ASHLAND PLANNING DEPARTMENT
PRE-APPLICATION CONFERENCE
COMMENT SHEET
October 9, 2024

SITE: 774 Lisa Lane
APPLICANT: Steve & Kate Moses
REQUEST: Physical & Environmental
Constraints Review Permit for and Exception to
Hillside Development Standards & Tree Removal

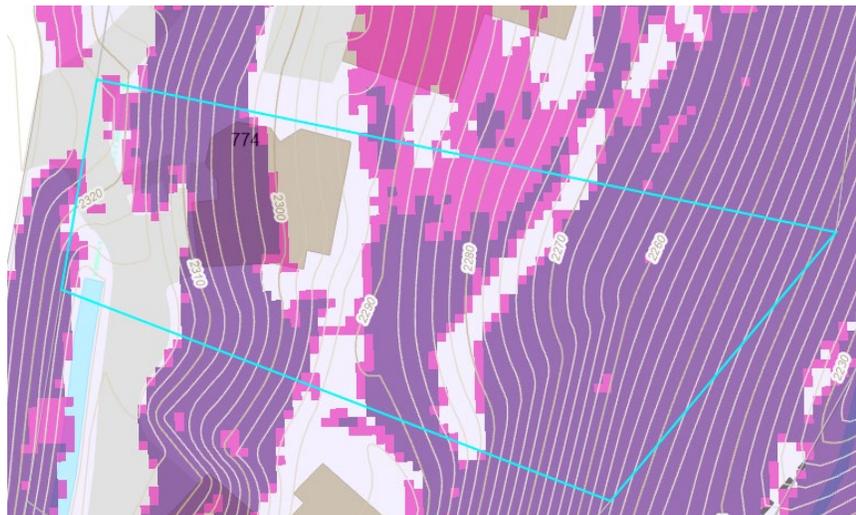
The property located at 774 Lisa Lane is a steeply sloped lot with much of the lot labeled as ‘severely constrained’ (slopes greater than 35%). On the image below (generated by City GIS) the dark magenta

are slopes greater than 35%, and light magenta showing slopes greater than 25%. The land use ordinance requires all new construction to happen on slopes less than 35%, however AMC 18.3.10.090.A.1.a allows for “Existing parcels without adequate buildable area less than or equal to 35 percent shall be considered buildable for one unit.” Because of steepness of the property and the presence of slopes greater
